Rezoning Transportation Analysis

Petition Number: 2026-057

General Location Identifier: 20301133

Date	Description
9-24-26	First Review (CM)

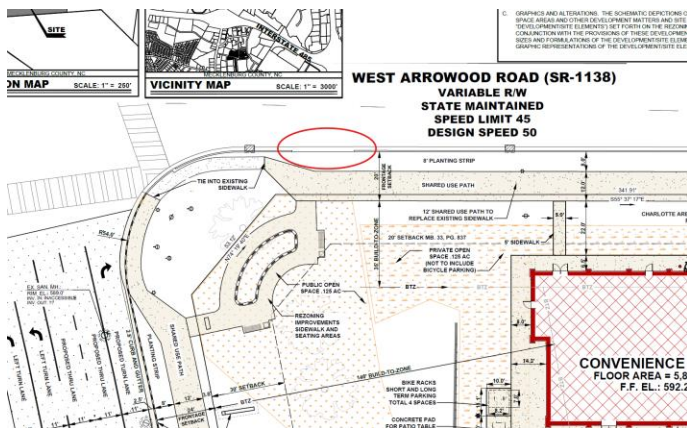
5. Add a conditional note specifying "A Right-of-Way Encroachment Agreement is required for the installation of any non-standard item(s) (irrigation systems, decorative concrete pavement, brick

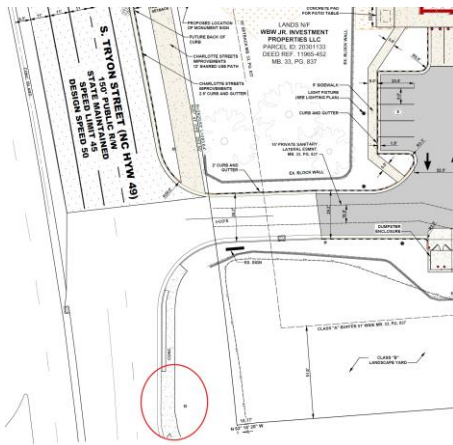
6. Revise site plan and conditional note(s) to commit to installing the Shared-use path along the entire project frontage including to the intersection. Provide two ada ramps with ramp-width matching the shared-use path at the intersection. Show SUP extending to the southern property line along South Tryon Road. Install ada ramps across existing access along South Tryon Road.
7. Revise site plan and conditional note(s) to commit to widening South Tryon Road to accommodate three travel lanes to meet the Charlotte Streets map requirements. You may also add a note to the site plan and conditional notes that coordination with NCDOT and CDOT will be required during permitting to ensure safe roadway and pedestrian facilities.
8. Remove conditional note 7.B.
9. Revise site plan to remove existing unused driveway along West Arrowood Road near intersection of South Tryon Street.

10. Revise site plan to remove existing unused driveway and curb ramp along South Tryon Road near the southwest corner of the parcel.
